RE: Premier Development LLC PDA 3-18, PDA 4-18 and S 3-18

CONDITION 6ALT Site Plan

PREMIER DEVELOPMENT
 OAK RIDGE MEADOWS SUBDIVISION

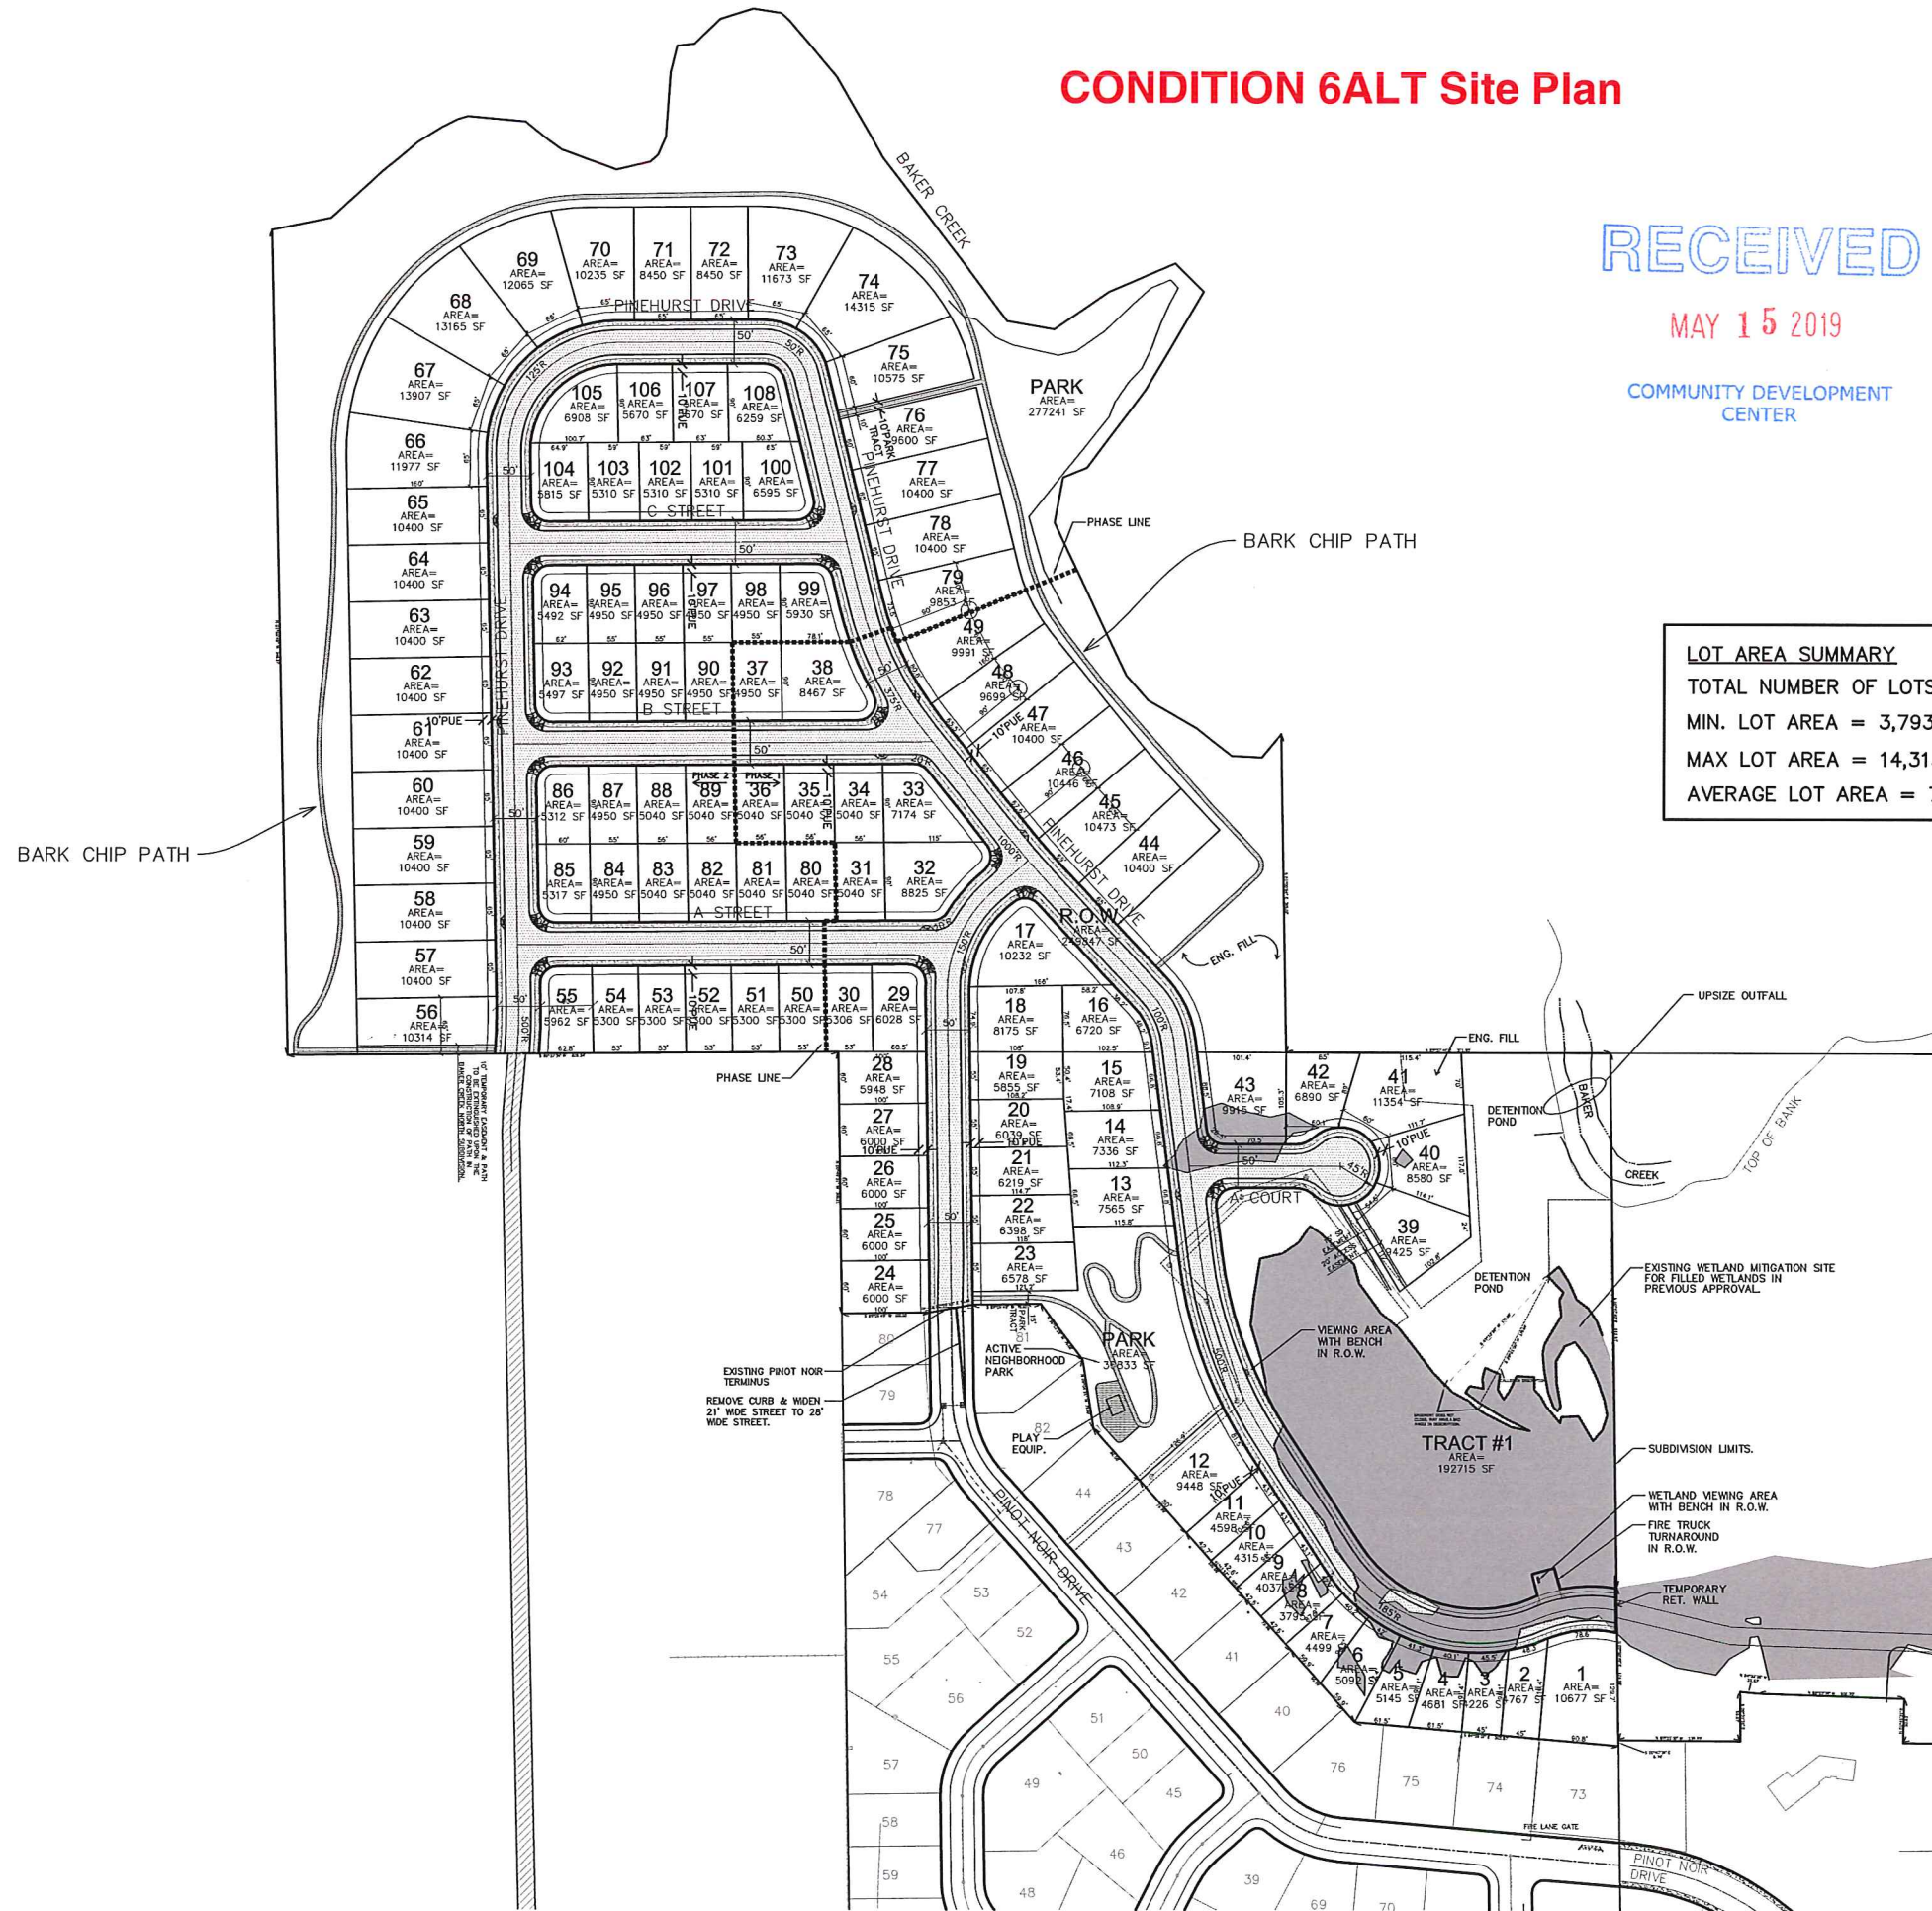
“The average lot size within the Oak Ridge Meadows subdivision shall be approximately 7,770 sq. ft. Provided however, that the applicant is authorized to remove some or all of Lots 34, 35, 41, 42 43 (as they are depicted on the application site plan Exhibit 6), and replace them elsewhere within the subdivision in substantial conformance with the site plan shown on the attached Exhibit 6ALT, if before the final plat of Phase I is recorded, the 100 Year floodplain is remapped by FEMA to include one or more of these lots within the 100 year flood plain or the applicant determines before recording the Final Plat that the reports of the applicant’s professional engineers establish that one or more of these lots have a greater risk of flooding than the published applicable FEMA maps depict. The replaced lots need not be the equivalent lot size to the removed lots. Rather, in such event, the average lot size within the subdivision is authorized to be approximately~~7,770~~ 7,302 and the minimum lot size within the subdivision is authorized to be approximately~~4950~~ 3,793. In all cases, the maximum lot depth to width ratio within the subdivision shall be 2.75 to 1. In such event, there would be ~~54~~ 64 lots in the subdivision that would be less than 7000 sq. ft.”

The exhibit that would go with such a condition, is attached to this letter. This condition would only be triggered by a FEMA approved LOMR before the final plat of Phase 1 is recorded or a competent engineering analysis is prepared by the applicant’s engineers suggesting that the potential for these lots flooding is greater than the FEMA mapping states and the applicant wishes to adjust the lots accordingly.
